**ANN ARBOR PLANNING DEPARTMENT STAFF REPORT SUPPLEMENT**

**SUBJECT: 841 Broadway Zoning and Area Plan (841 Broadway Street)  
File Nos. Z18-018 and AP18-003**

## ANN ARBOR PLANNING DEPARTMENT STAFF REPORT

Re Response to March 5 City Planning Commission Comments  
PUD Zoning District Review  
Broadway park, Ann Arbor, MI

AREA 1

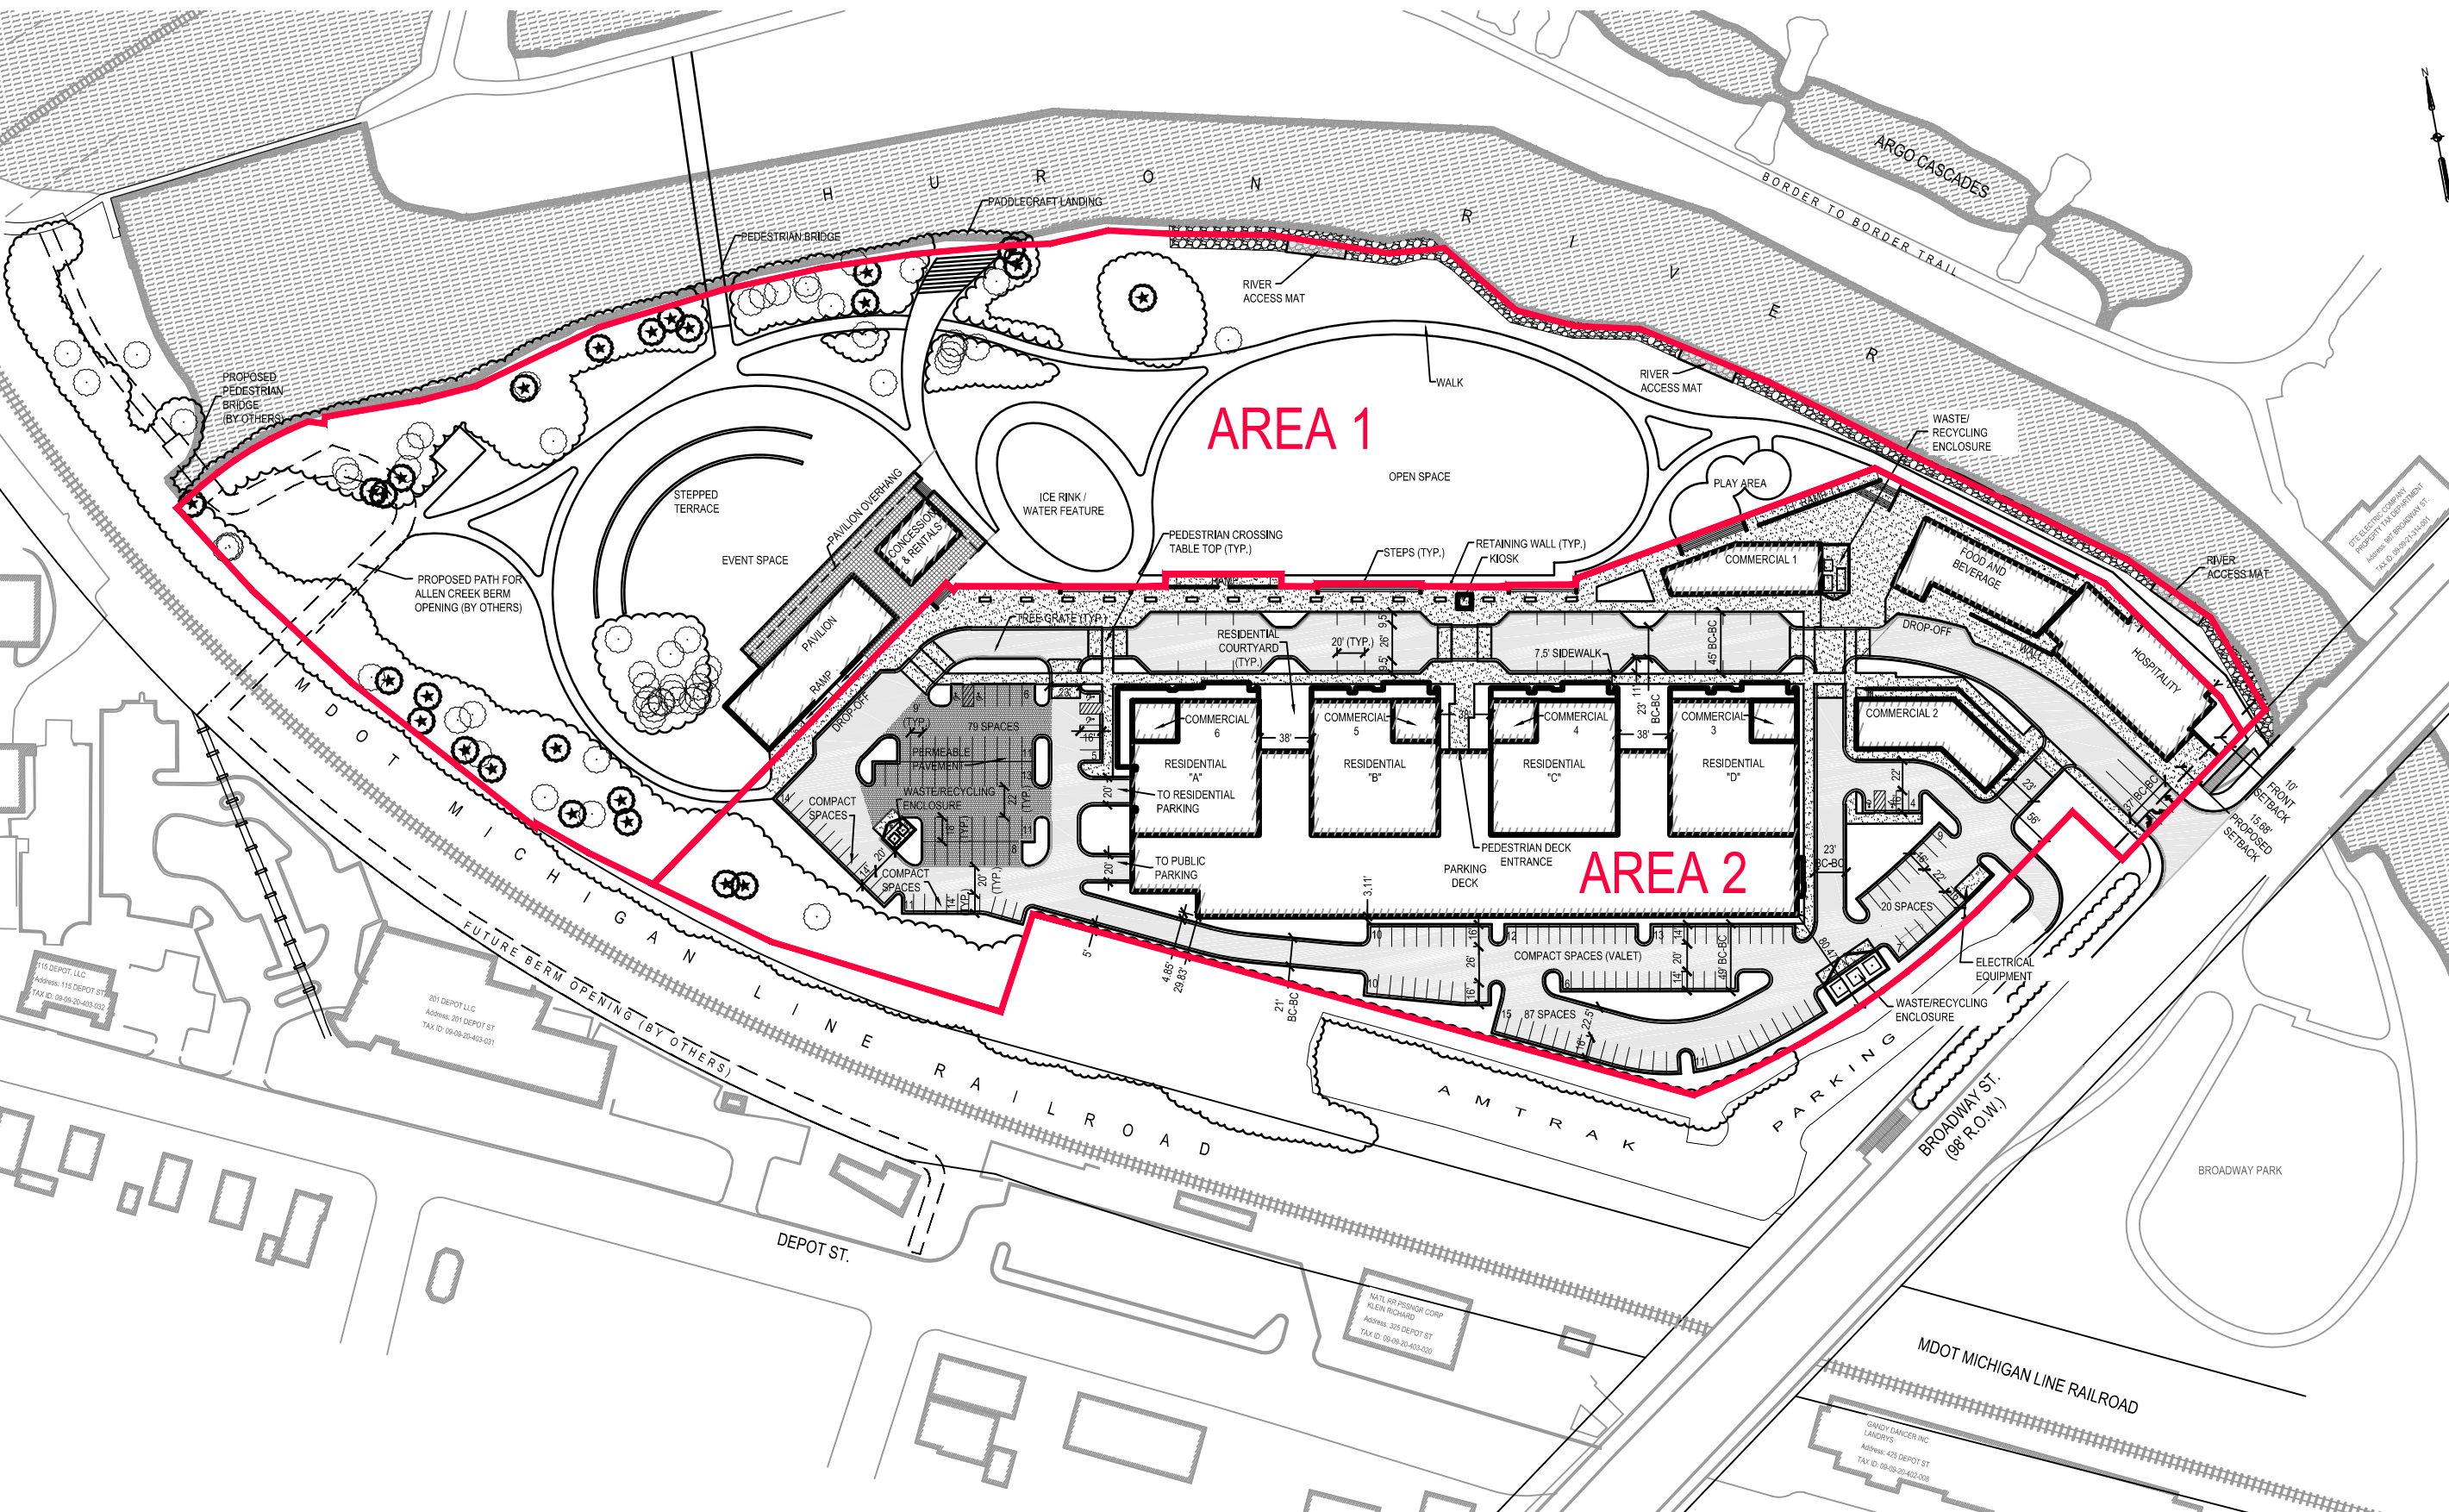
In order to help delineate designated use areas, the attached map indicates areas where proposed uses are permitted depending on access provided to the site. These area designations correspond directly to the supplemental regulations where permitted/required uses are described in detail.

Required Principal Uses: Open space - The approximate area of Area 1 as designated in Attachment A shall be designated as permanent open space with limited recreational and associated uses permitted. In no case shall such area be less than six contiguous acres.

Required Principal Uses: Multiple-Family Residential: Minimum 90 units. These units will have a maximum of 3 bedrooms per unit, with the exception of not more than eight (8) units which may have up to five (5) bedrooms.
